# Japan contributions on Annex 4 TF

19<sup>th</sup> April, 2017  
WLTP IWG

# Japan Proposal on Wind Tunnel Method

## To clarify the Wind Tunnel Method...

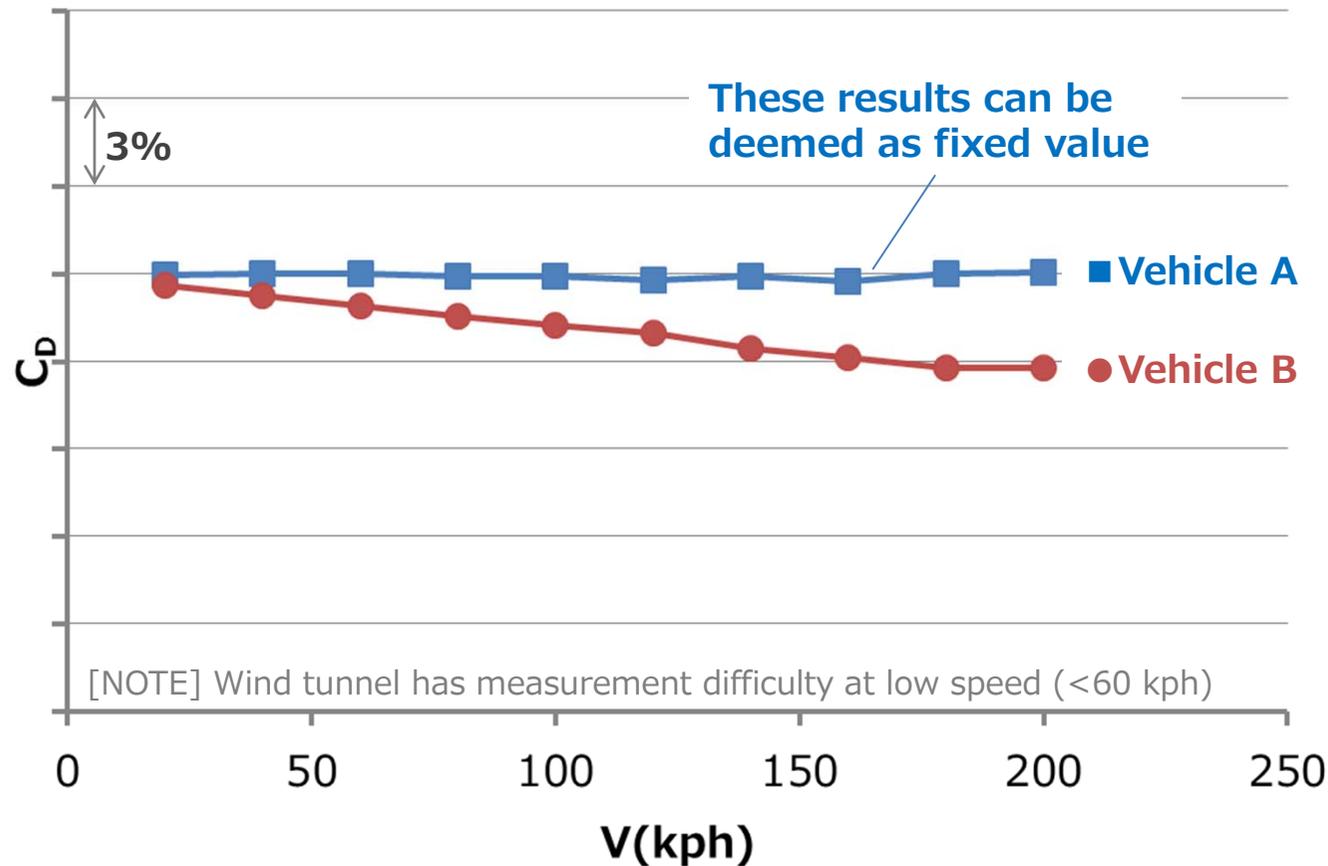
## ■ There is no wind tunnel test method written in Annex 4.

## ■ This leads many interpretations for “reference speed” to measure aerodynamic drag using wind tunnel;

- At only one wind speed?
- At several wind speeds?
- At every wind speeds as same as coast down method?  
(this is ridiculous!!)

3.3.1. Measurement of aerodynamic drag shall be performed according to 6.1.2.2 of ISO 10521-1 or 2.3.1.2. of JIS D1012 2005\*.

3.3.2. The road load value measured by wind tunnel method is recommended to calculate using the results of **2 or more wind speeds**\*\* and 0 kph. The aerodynamic drag at 0 kph shall be equal to 0. In the case that the vehicle has movable aerodynamic body parts, paragraph 4.2.1.5. of this annex shall apply.

6.2.3. Measurement with the wind tunnel method according to paragraphs 3.3. and 6.3. to 6.7. inclusive of this annex shall be performed on the same three vehicles as selected in paragraph 6.2.1. of this annex and in the same conditions, and the resulting road load coefficients,  $f_0$ ,  $f_1$  and  $f_2$ , shall be determined. The certification tests shall be performed with the procedure used at wind tunnel approval.

Aerodynamic drag shall be measured according to 3.3 of this Annex.

## Graph of Vehicle B if Aero-drag Measured Only @ 140kph

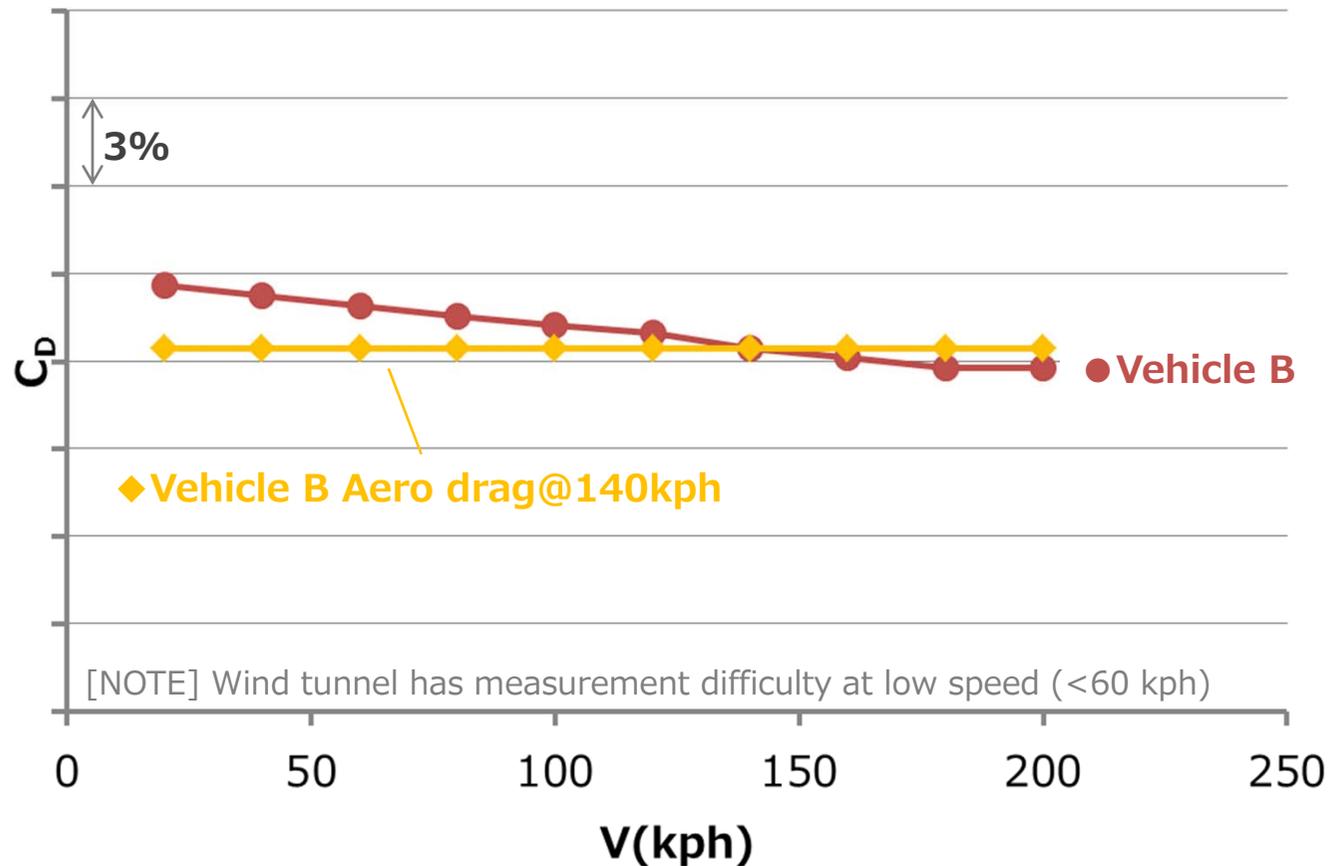
- The drag difference depending on speed assumed to be caused by many reasons. However, those are too complex to separate and correct at calculation.

For vehicle B, MAX 3% difference cause at low speed.

## Effect on Road Load Values of Vehicle B

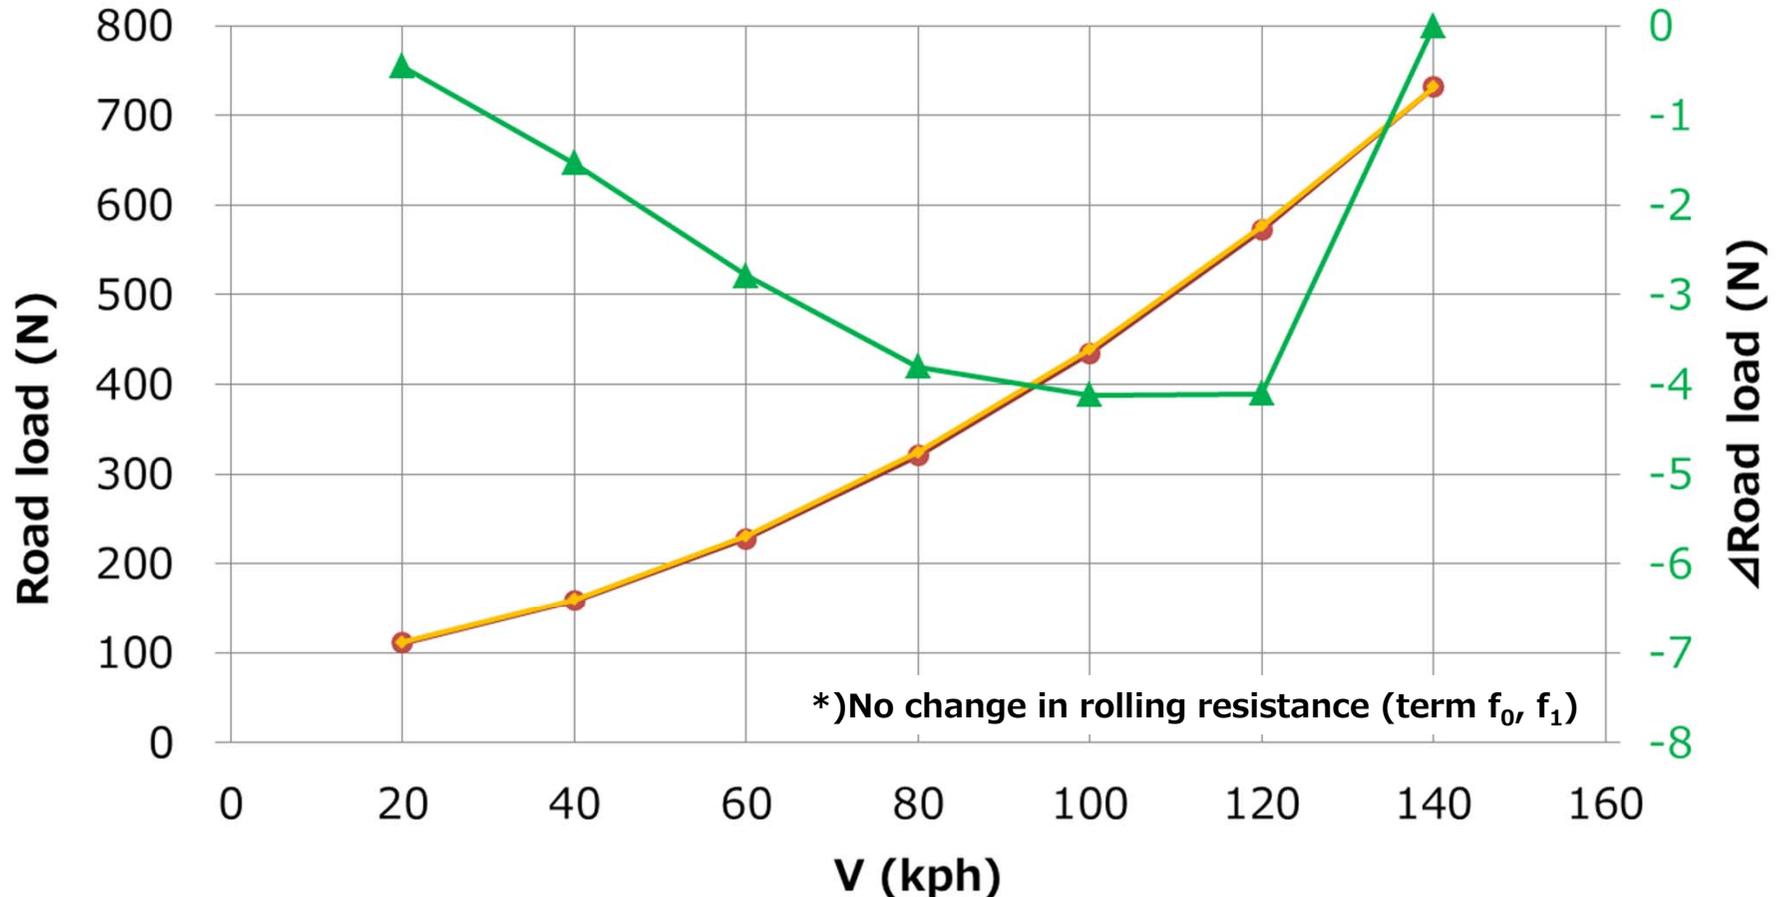
[For Vehicle B] Road load: **Max  $\Delta 4N$**  / Cycle energy:  **$\Delta 0.5\%$**  (@4 Phase) 8/11

[NOTE] "3 %/ 4N" is the data only from a certain vehicle which was tested at several points. Which means, other vehicles might have more differences or less.  
No one knows until the vehicle is tested at several points.

**Question: Can this situation be ignored or be permitted?**

# Why recommend 2 or more Speed Points, not all?

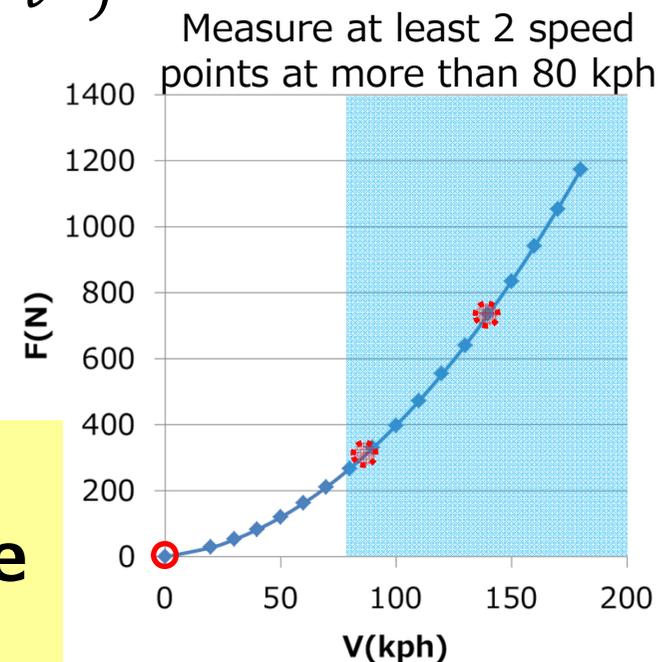
- The wind tunnel test equipment tend to have **low accuracy** on measuring aerodynamic drag **at low speed**. (mostly less than 80 kph. Ref. 6.1.2.2 of ISO 10521-1 or 2.3.1.2. of JIS D1012\_2005)
- Road Load equation consists of ternary quadratic equation. **With more than 3 road load results (including 0 kph), road load curve can be determined.**

**Considering accuracy and test burden, "measurement at 2 or more wind speeds" is recommended.**
